| Illinois Tollway Standard Drawings Revisions |

| Section L Fiber Optic | |
| | Effective: 03-01-2024 |
| L1-06 | Fiber Optic System Typicals and Drawings |

FIBER HANDHOLE SITE DETAIL AND GROUNDING
THIRD PARTY CONDUIT

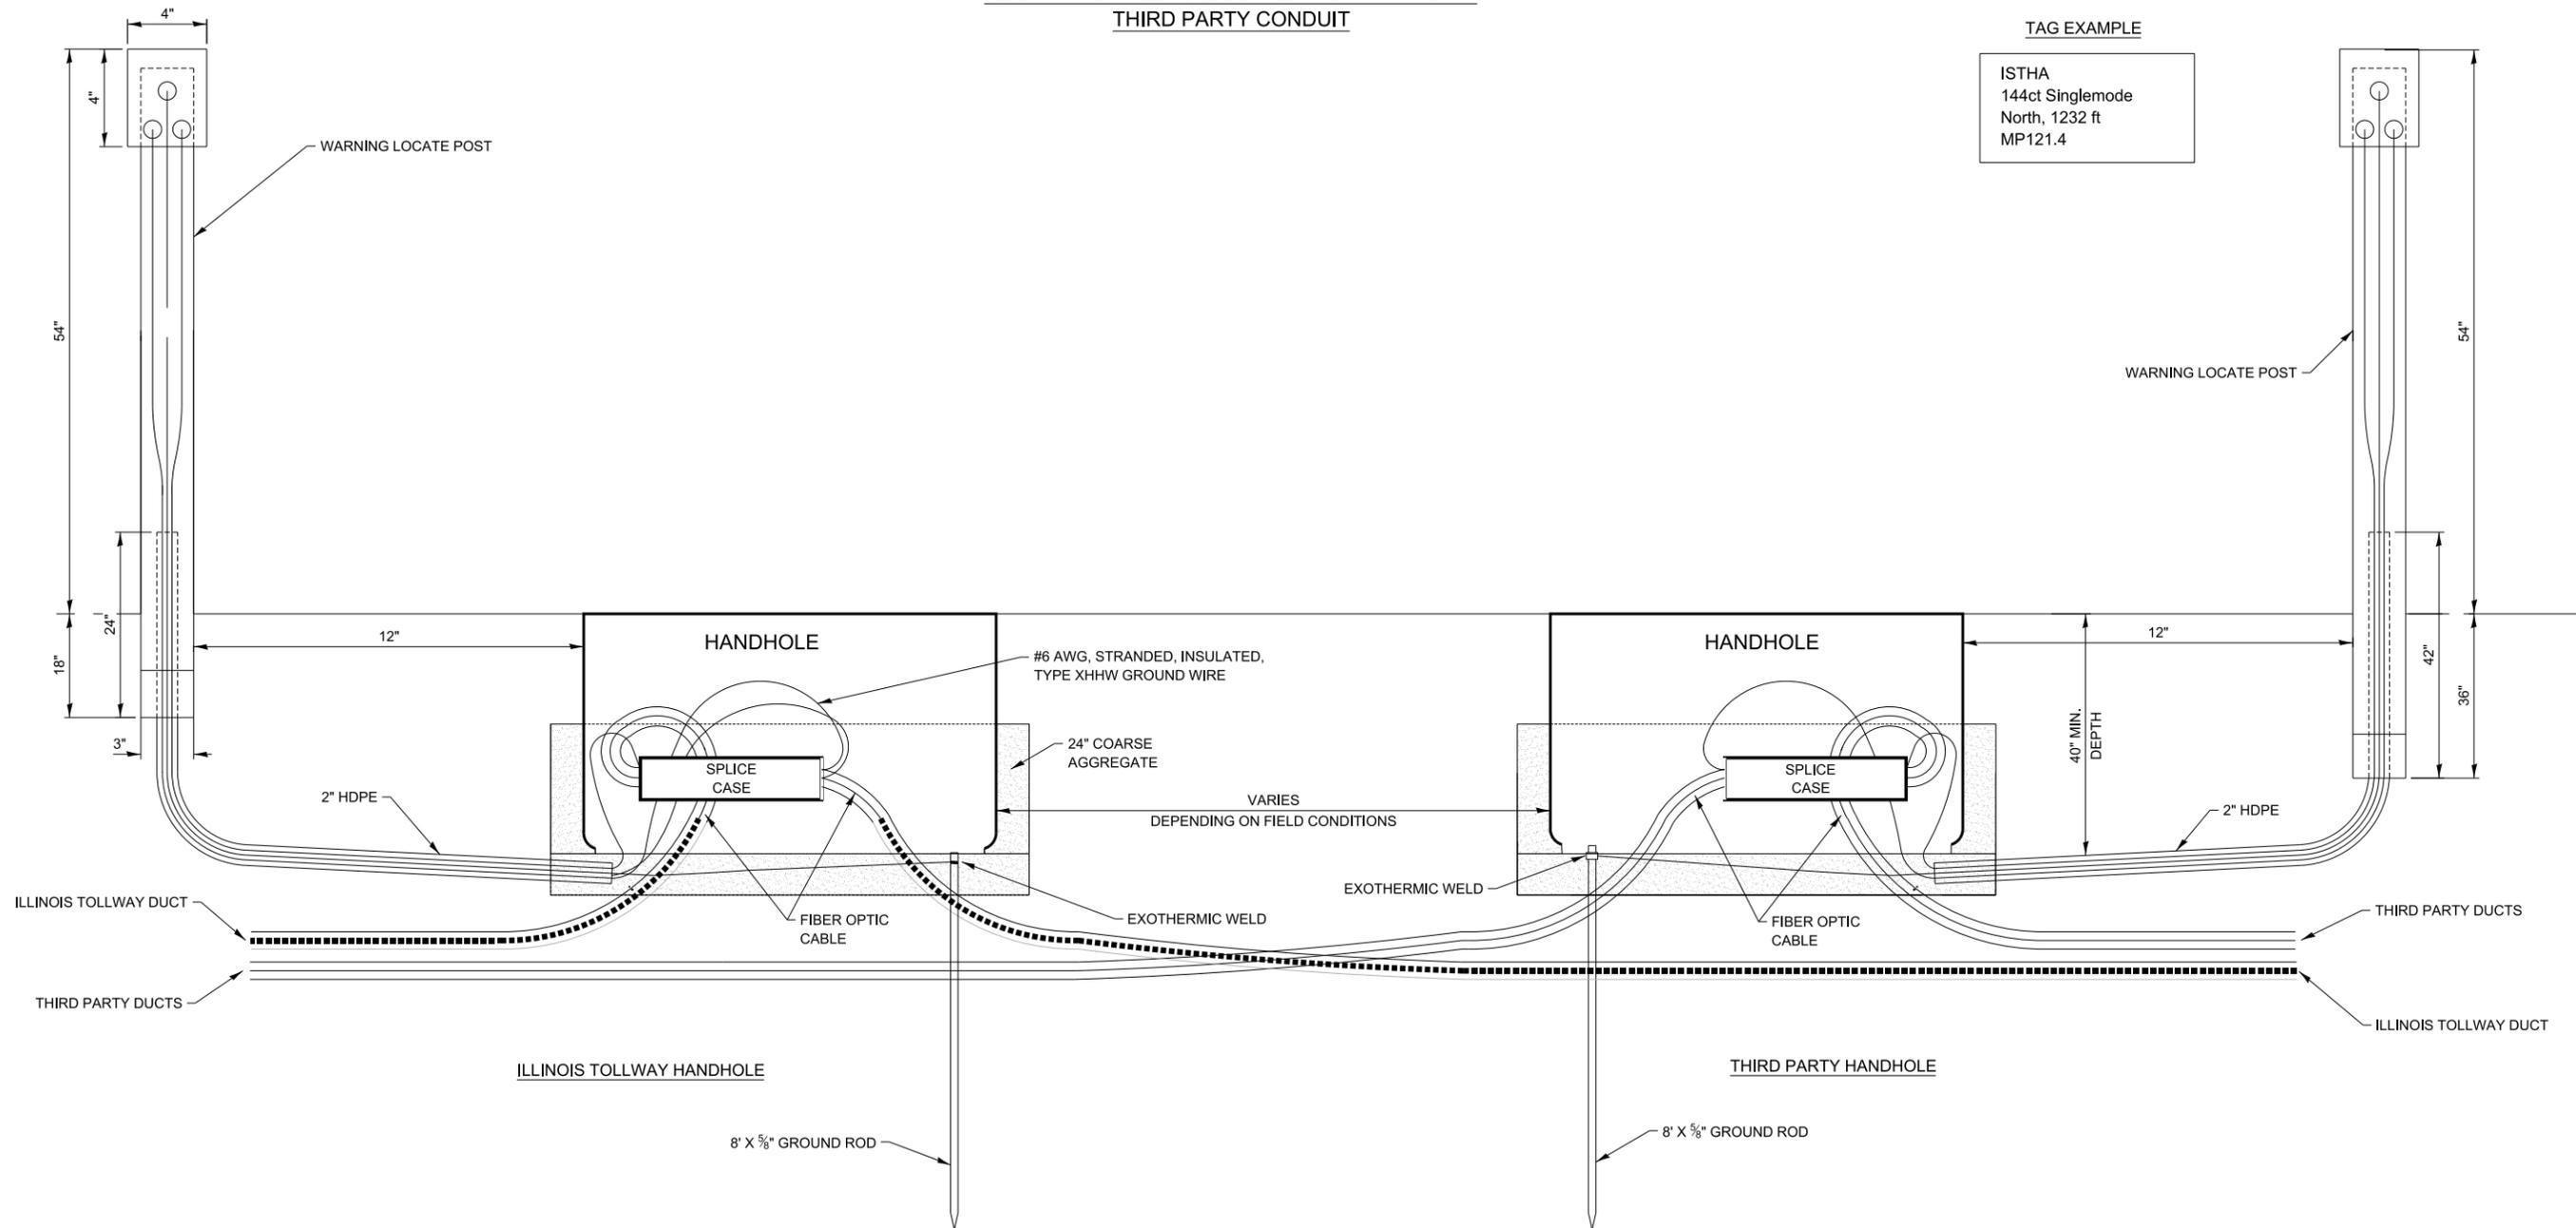
| Section L Fiber Optic | |
|---|---|
| Sheet 9 | Removed Handhole - Plan View. |
| | Modified Note 1. |
| | Modified Note 2. |
| | Modified Note 7. |
| | Added detail label "Warning Post". |
| | Removed note "Place HDPE over fiber optic cable to provide crush protection extend HDPE 1' inside handhole". |
| Removed note "Handhole shall not be installed on steep banks or slopes where the cover cannot be leveled within a tolerance of one inch (1") of drop to twelve inches (12") of grade and remain buried. | |

FIBER OPTIC SPLICING DETAILS

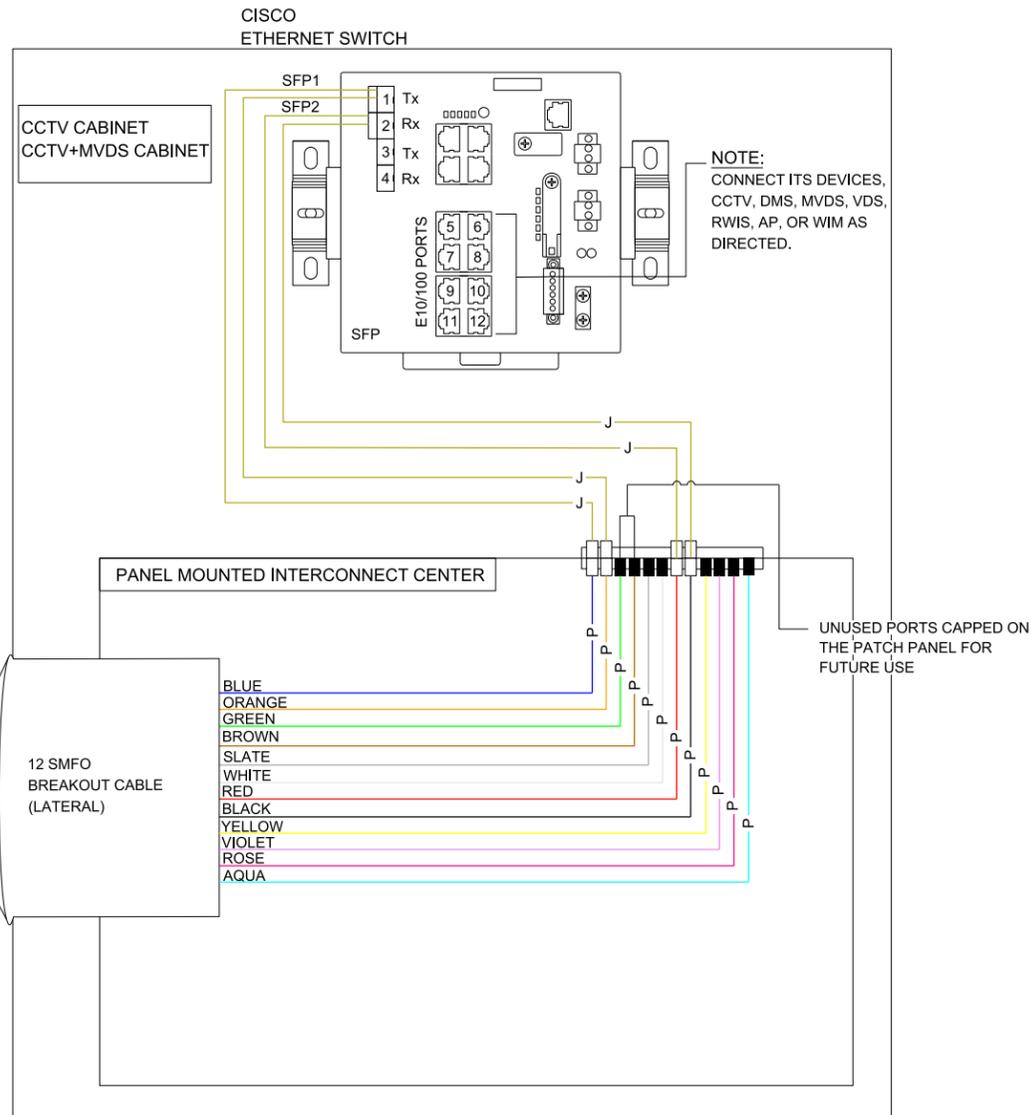
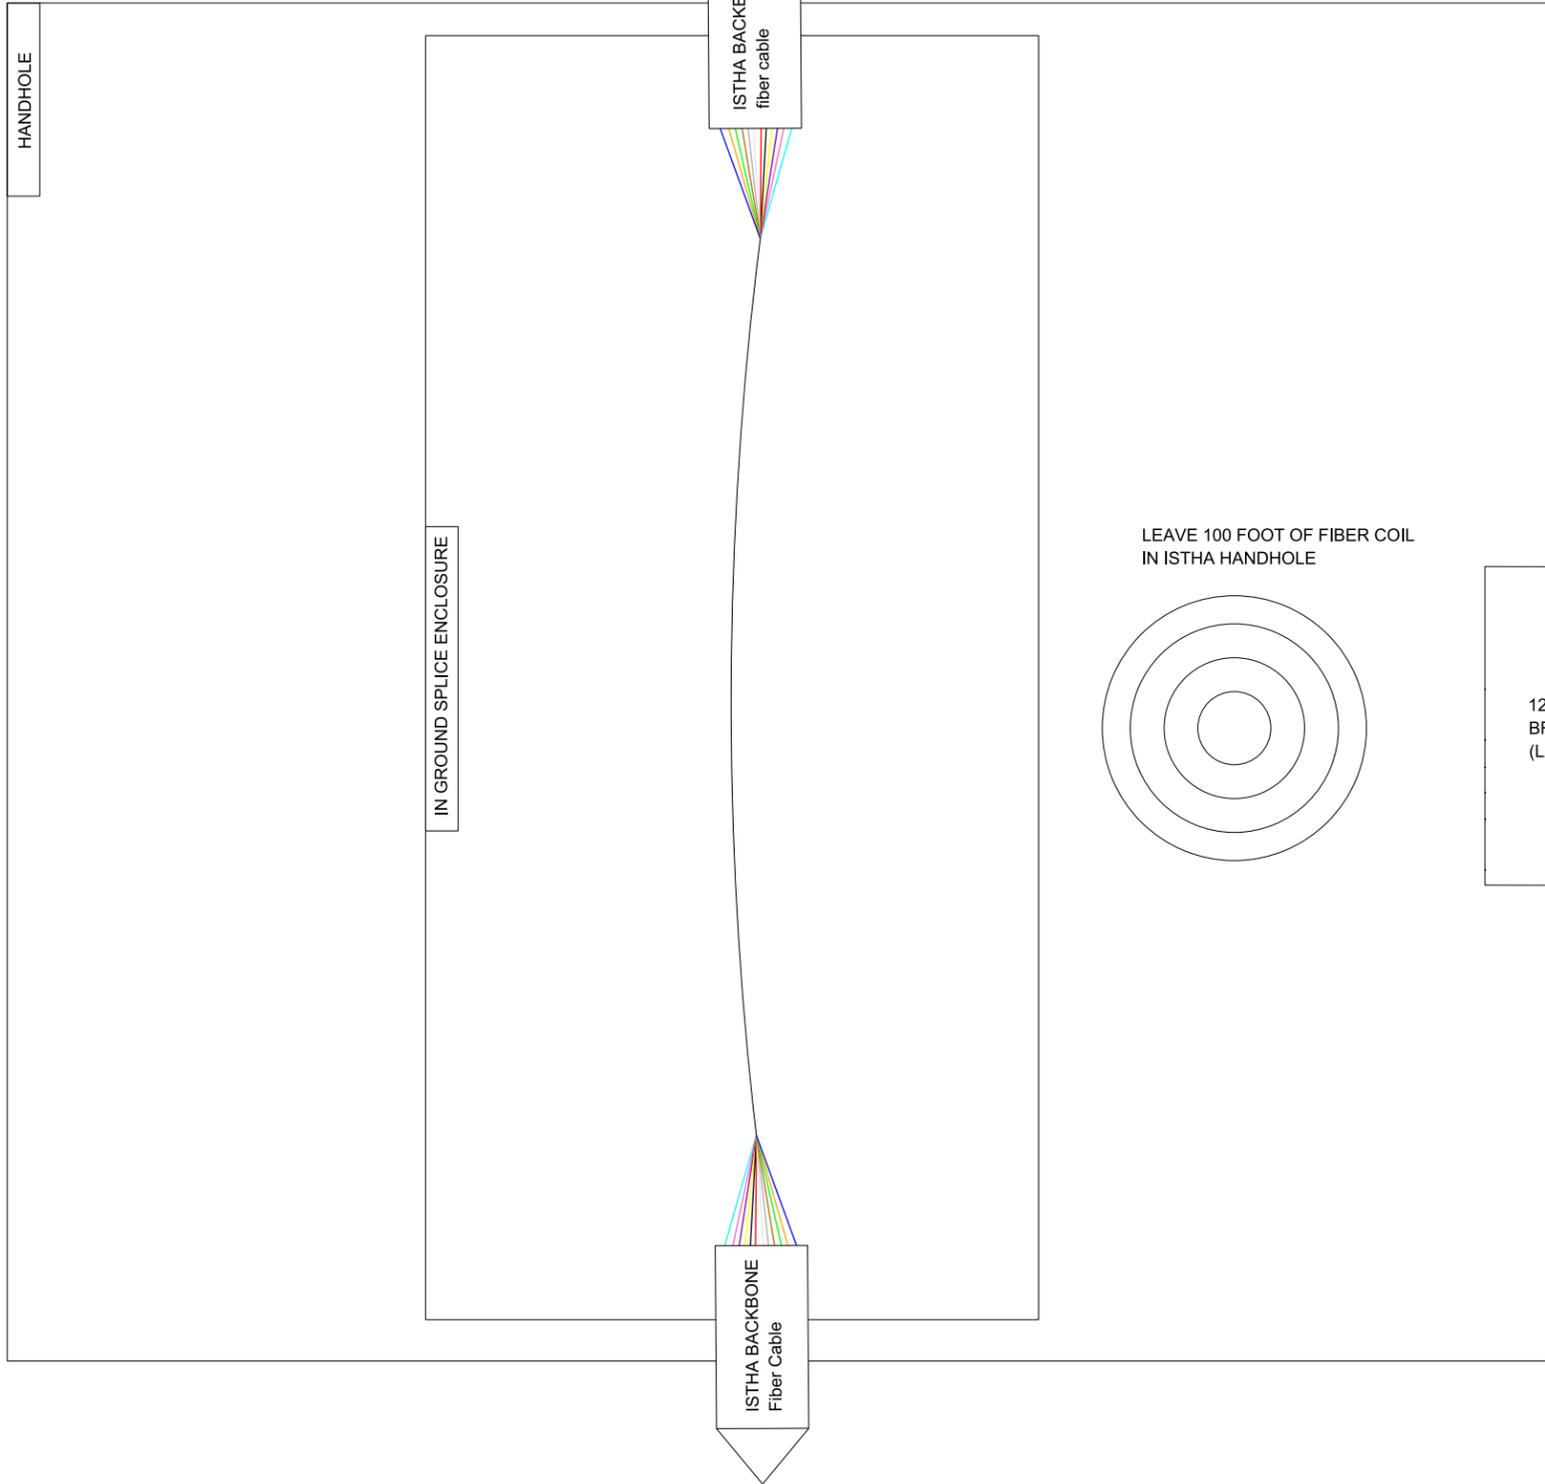
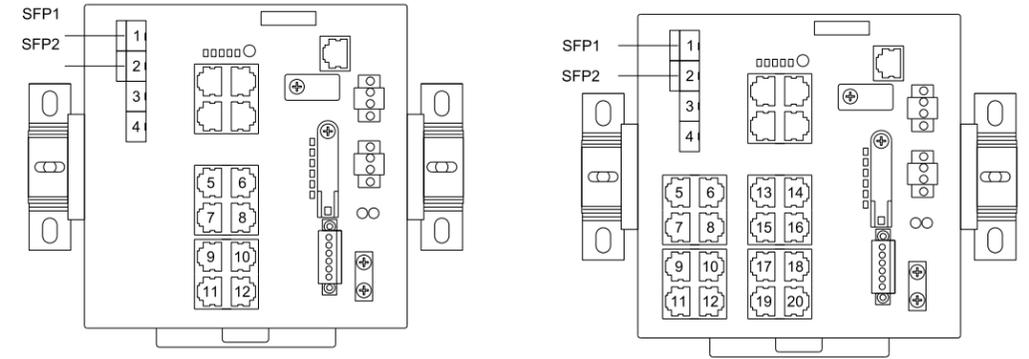
| Section L Fiber Optic | |
|---|---|
| Sheet 1 | Modified drawing. |
| Sheet 2 | Modified Note 1. |
| | Modified Note 2. |
